ADDENDUM NO. 02

RANKIN TRAILS AMPHITHEATER AND BASEBALL PARK

Rankin County, Mississippi

WBA Proj. # 2215/2315

C0.4
Existing
Conditions

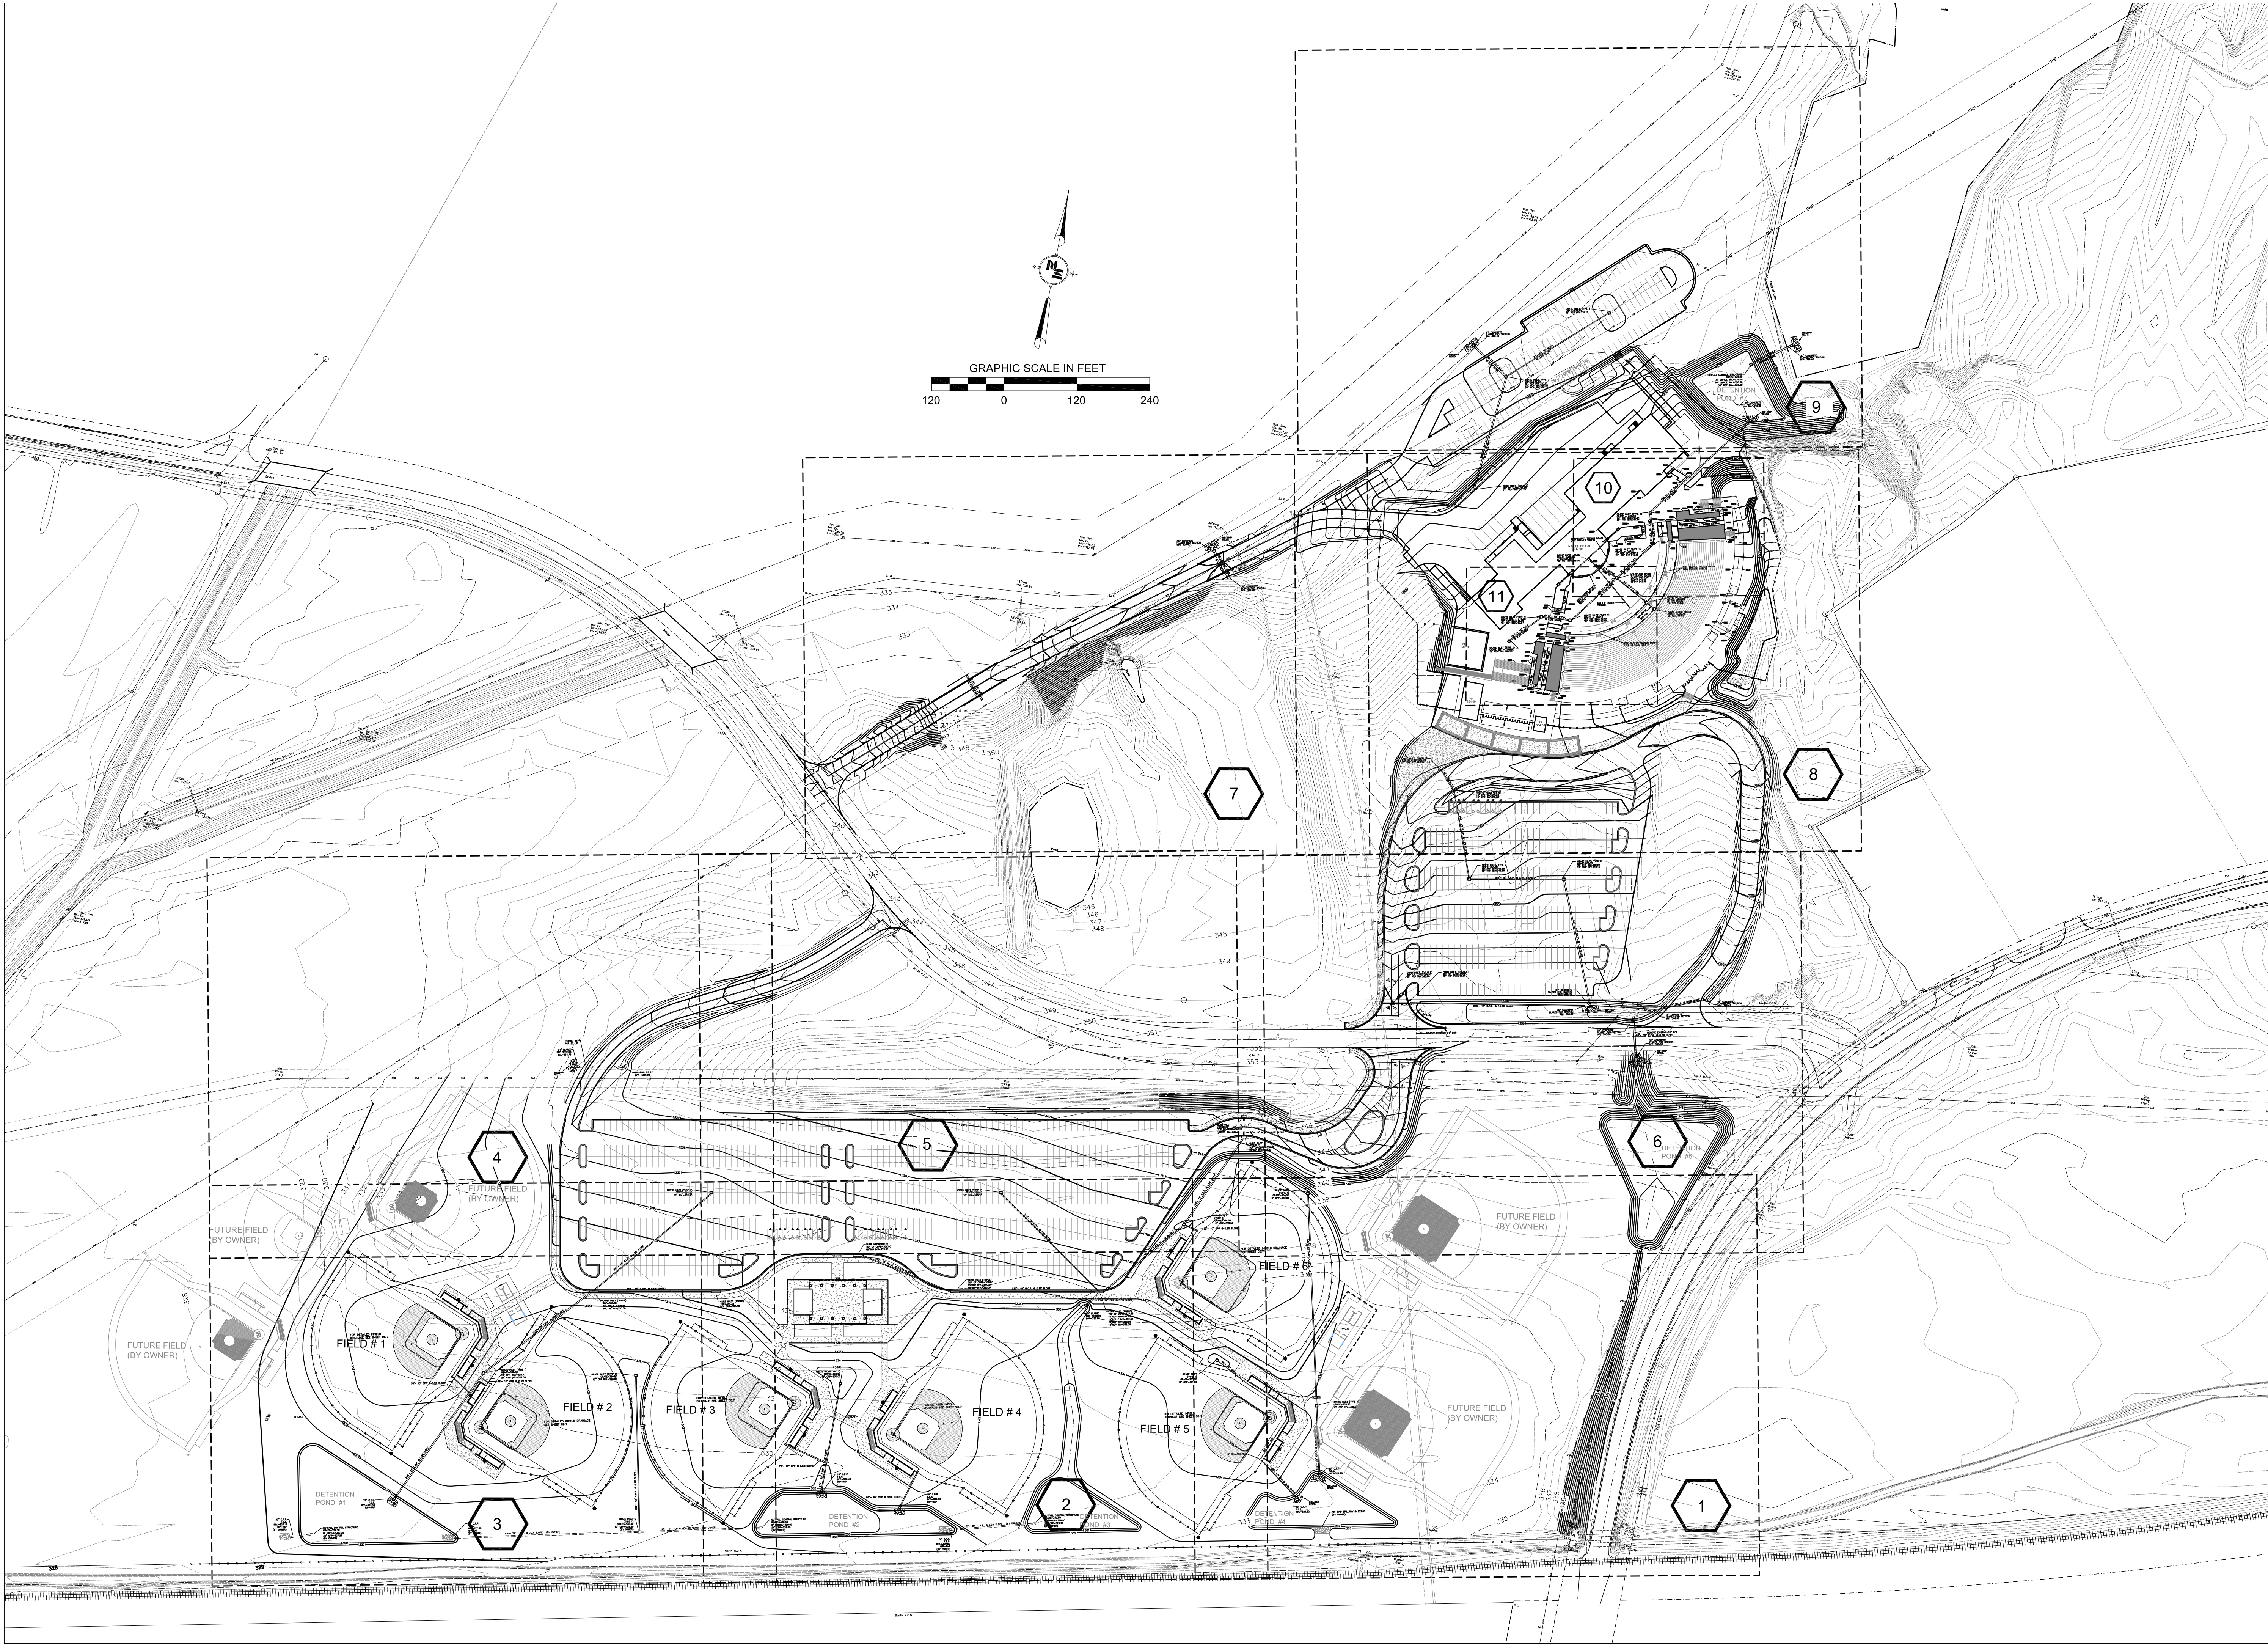
ITEM NO. 10 SHEET C0.4 EXISTING CONDITIONS

REVISE per enclosed sheet C0.4. Existing conditions have been revised.

C3.4
Surfacing Plan

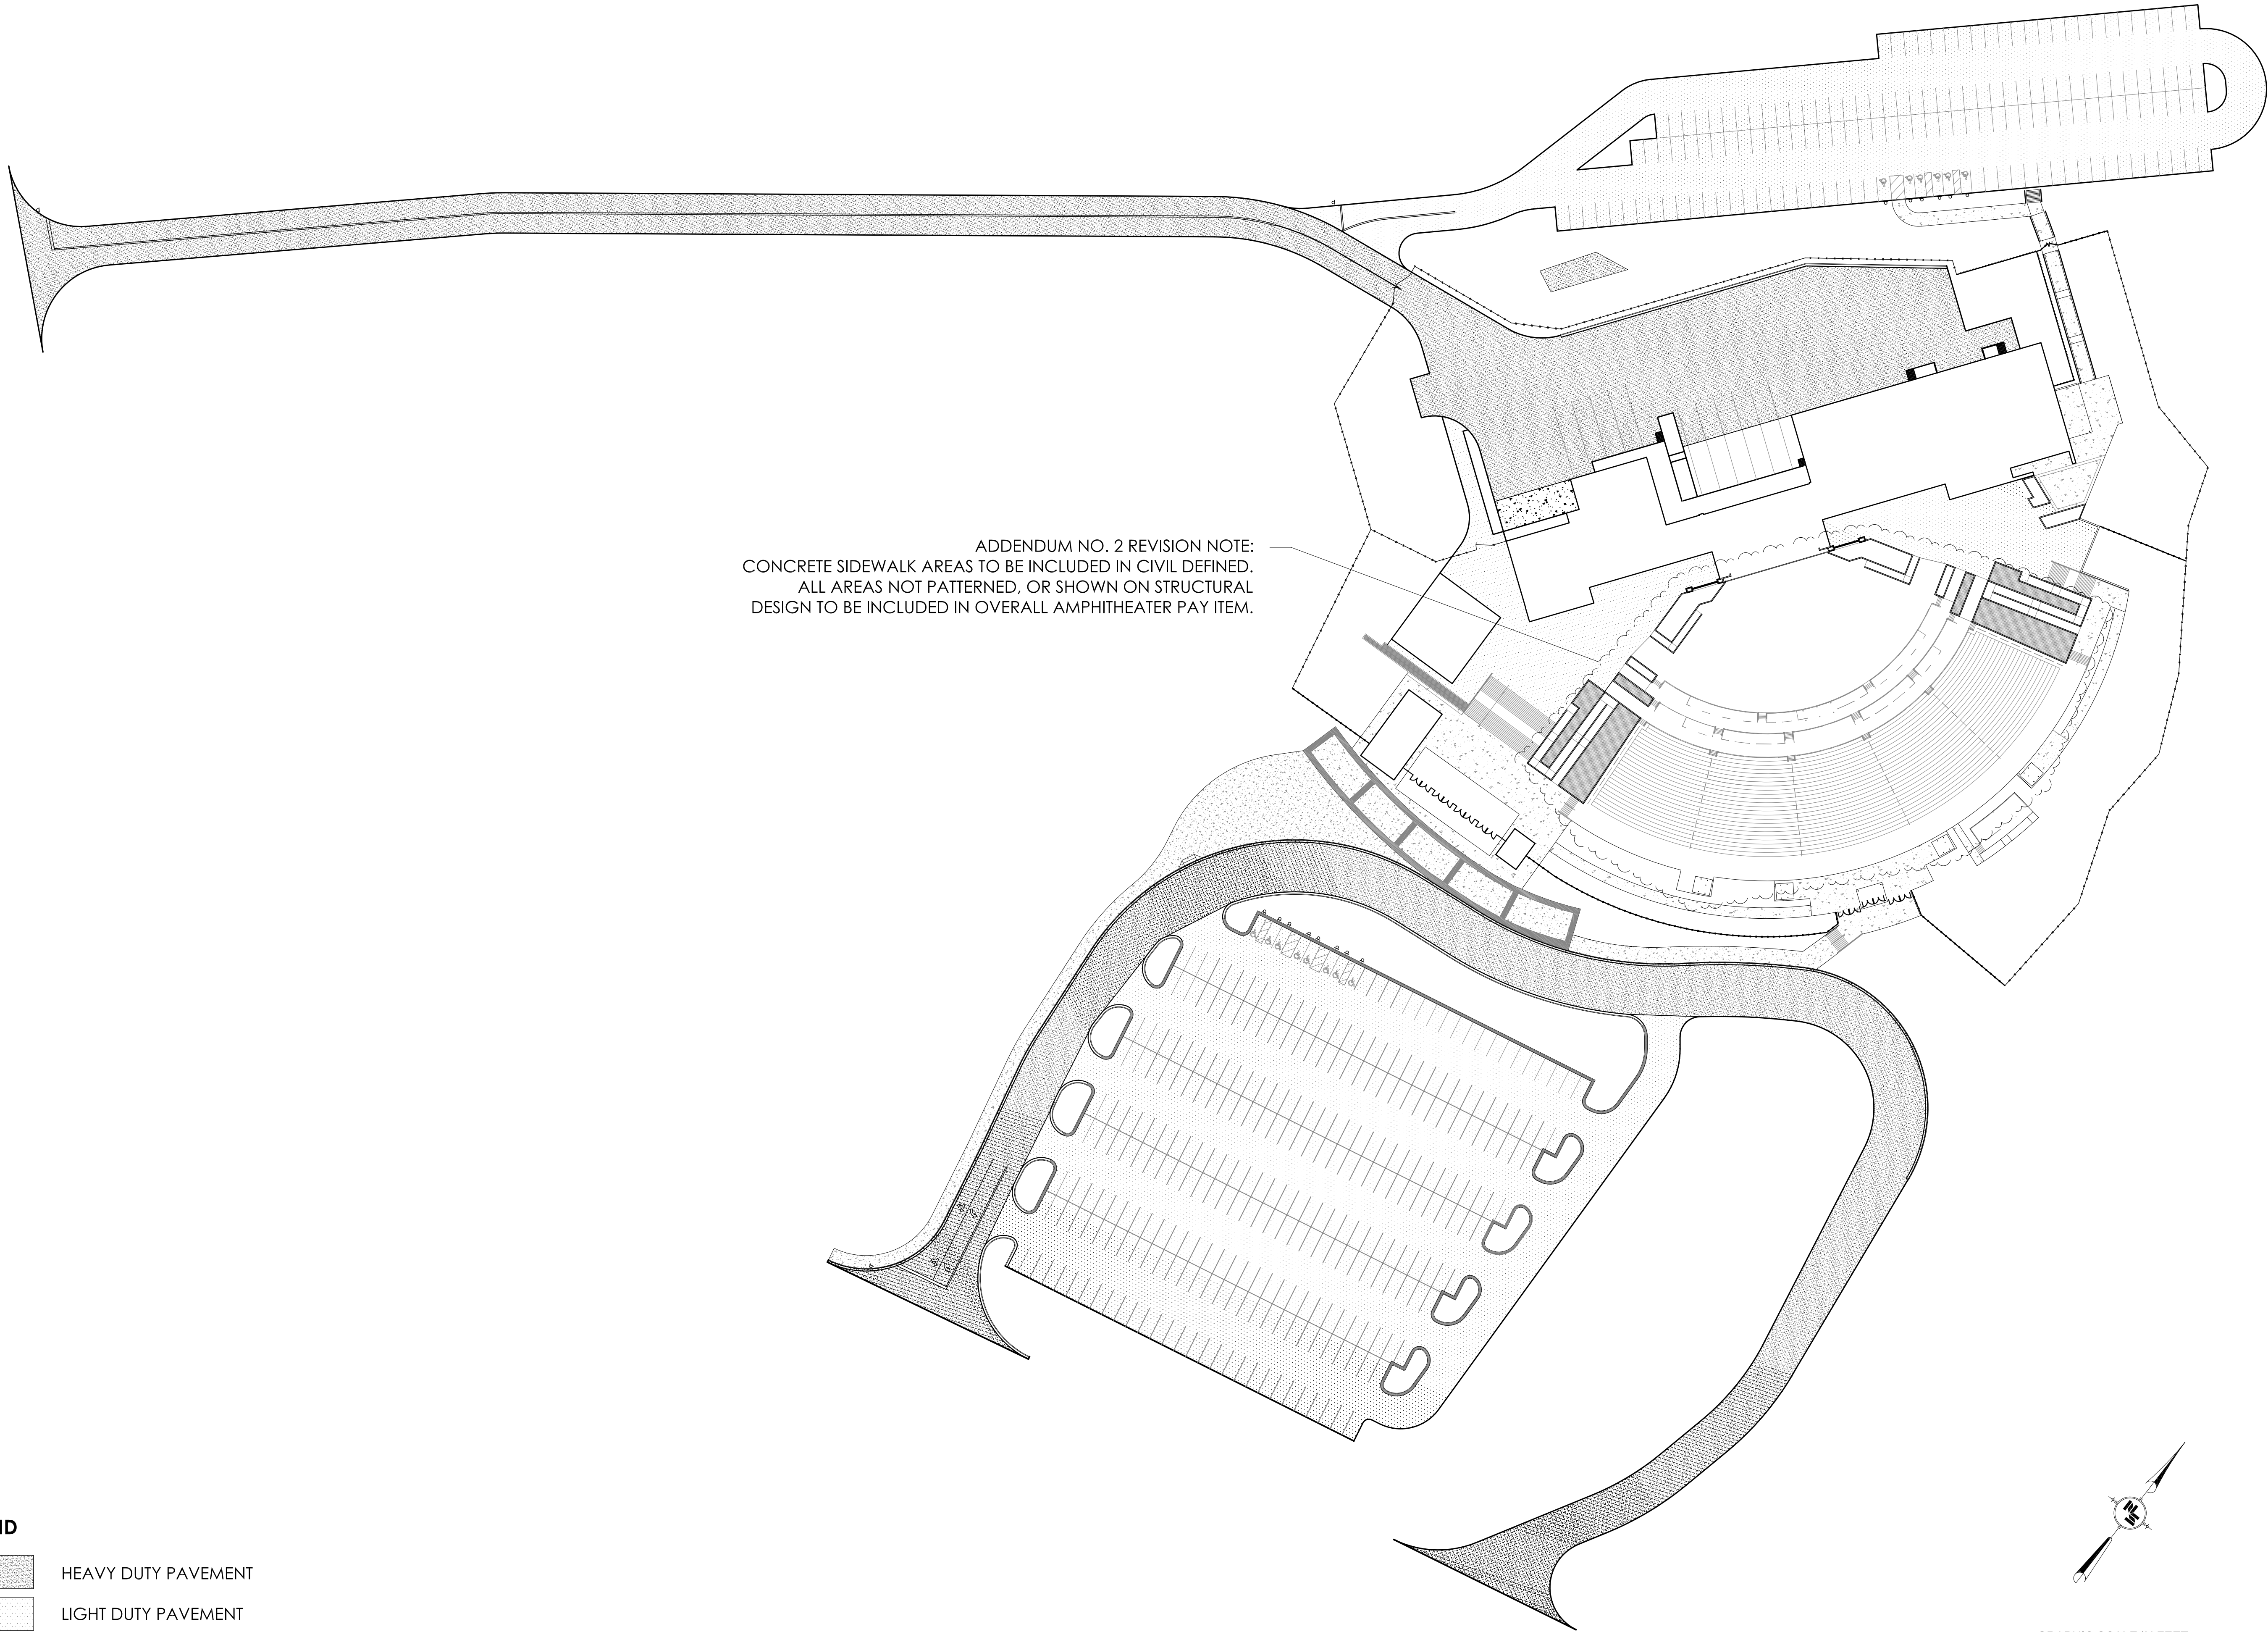
ITEM NO. 14 SHEET C3.4 SURFACING PLAN

REVISE per enclosed sheet C3.4. Civil construction elements defined. Limits of concrete sidewalk revised.

ADDENDUM NO. 2 REVISION NOTE:
CONCRETE SIDEWALK AREAS TO BE INCLUDED IN CIVIL DEFINED.
ALL AREAS NOT PATTERNED, OR SHOWN ON STRUCTURAL
DESIGN TO BE INCLUDED IN OVERALL AMPHITHEATER PAY ITEM.
